MFN 08-888

Response to NRC Request for Additional Information Letter No. 253 Related to ESBWR Design Certification Application

Licensing Topical Report (LTR) NEDO-33337 ESBWR Initial Core Transient and Accident Analysis

RAI Numbers 15.2-42, 15.2-44 through 15.2-47, 15.2-49 and 15.2-51

Figure 15.2-46-1

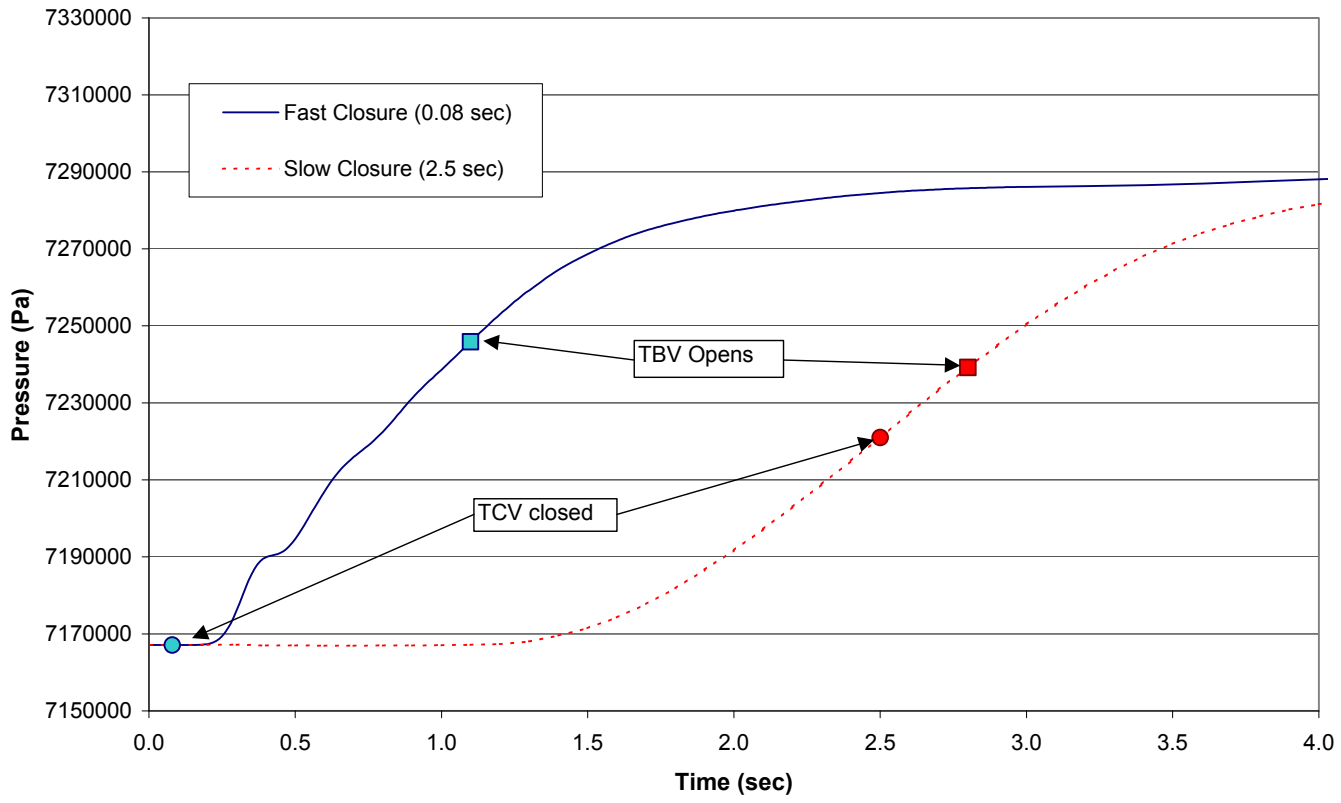
Explain the trip logic for turbine control valve closure and turbine bypass valve opening. NEDO-33337, Table 2.3-6, "Sequence of Events for Fast Closure of One Turbine Control Valve", the turbine bypass valve starts to open 1.02 seconds after the TCV completes closure. In Table 2.3-7,"Sequence of Events for Slow Closure of One Turbine Control Valve", the turbine bypass valve starts to open 0.3 seconds after the TCV completes closure. Explain the trip logic or provide a reference for the explanation.

In both analyses, “Fast Closure of One Turbine Control Valve” and “Slow Closure of One Turbine Control Valve”, the closure of the turbine control valve (TCV) is an initiating input into the TRACG calculation. The valve closes in 0.08 seconds in the “fast” scenario and in 2.5 seconds in the “slow” scenario. The turbine bypass valve (TBV) operation is controlled by the Steam Bypass & Pressure Control System (SB&PC), as described in the ESBWR DCD, Tier 2, Subsection 7.7.5. The opening of the TBV is not a direct function of the closure of the TCV, rather it is dependent on the reactor dome pressure. For more detail on the logic, refer to DCD, Tier 2, Subsection 7.7.5 and Figure 7.7-5.

The dome pressure response for the two cases is different. In the fast-closure case, the TCV is completely closed in 0.08 seconds rather than in 2.5 seconds for the slow-closure case; therefore, the pressure increase is fast and the remaining TCVs open sooner compared to the slow-closure case. Figure 15.2-46-1 shows a plot of the pressure for the two cases with the timing of the TCV closure and the TBV opening. The figure reveals that the TBVs open at similar dome pressures.

Figure 15.2-47-1 Feedwater Temperature Decrease During the "Generator Load Rejection with Turbine Bypass" event.

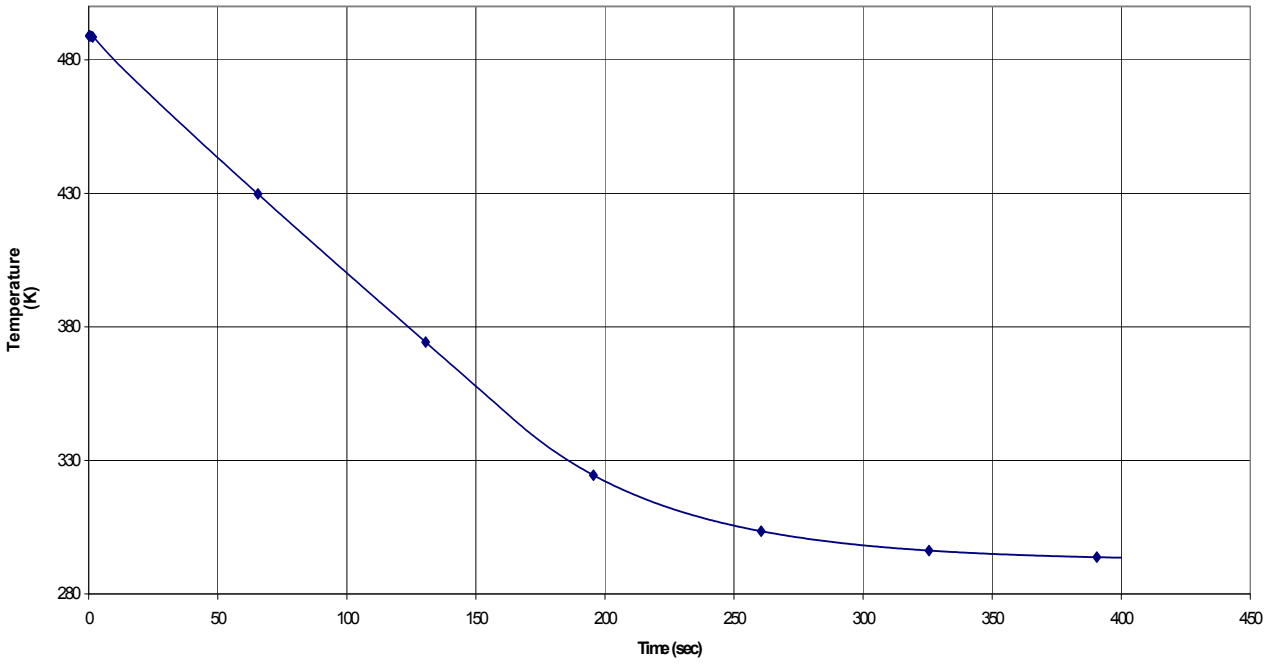
Explain the mismatch between the steam/feedwater flow rate and power. NEDO-33337, Figure 2.3-4a and 2.3-6a, the steam flow rate and the feedwater flow rate are about 50 percent of rated while power is about 75 percent of rated. Provide the transient steam and feedwater temperatures or provide an explanation for the mismatch between steam/feedwater flow rate and power.

The core power is affected by more parameters than just the feedwater flow rate; the feedwater temperature also affects it. Figure 15.2-47-1 shows a decreasing feedwater temperature for the "Generator Load Rejection with Turbine Bypass" event. The feedwater temperature during the "Turbine Trip with Turbine Bypass" event is similar. The decrease in feedwater temperature is the cause for the power and steam/feedwater flow rate mismatch because the reduced feedwater temperature increases the core inlet sub-cooling therefore more core power is used to increase the coolant to saturation therefore less power is available to generate steam. The exit steam is at the saturation temperature corresponding to the dome pressure and the steam temperature is constant after approximately 100 seconds as the dome and steam line pressure stabilizes, which can be seen in NEDO-33337 Figures 2.3-4d and 2.3-6d.
